CITY OF WESTFIELD, IN
Advisory Planning Commission Meeting Agenda_06_20_2016

1606-DDP-21

Urban Vines

Request: Detailed Development Plan approval for a vineyard and winery building on 5 acres +/-, and associated waivers.

C2.4

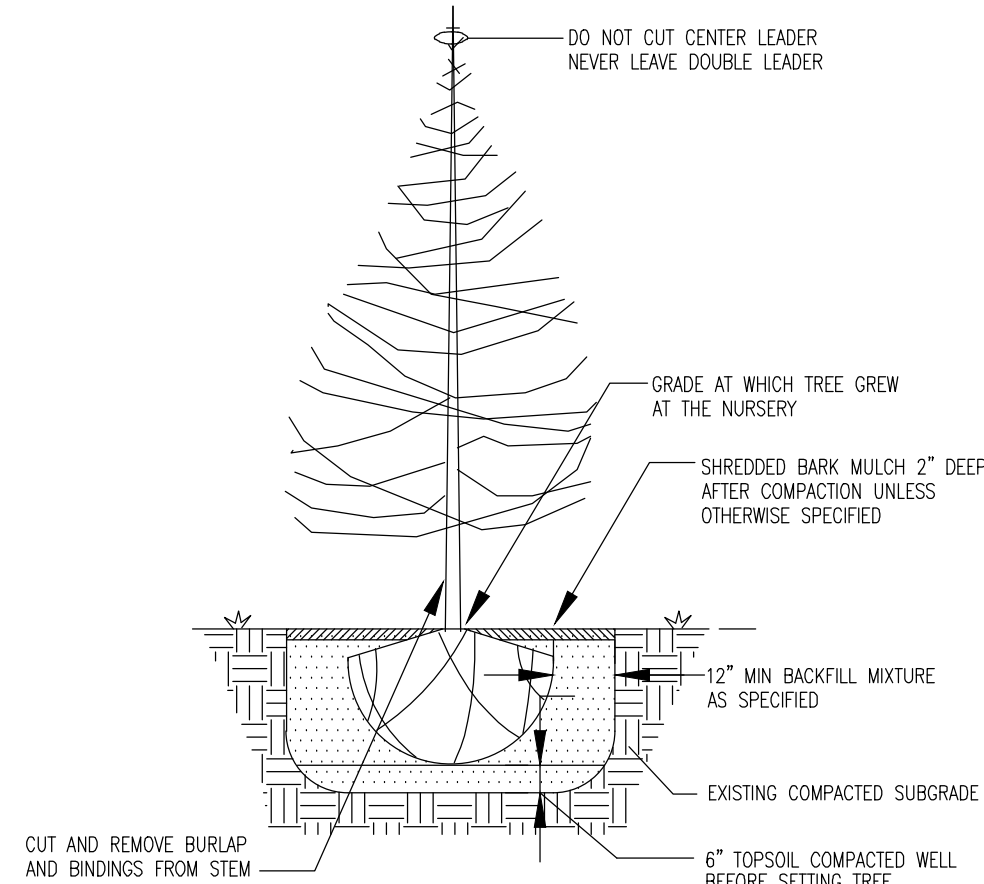
Comment: Please correct scale on Landscaping Plan sheet C2.4.
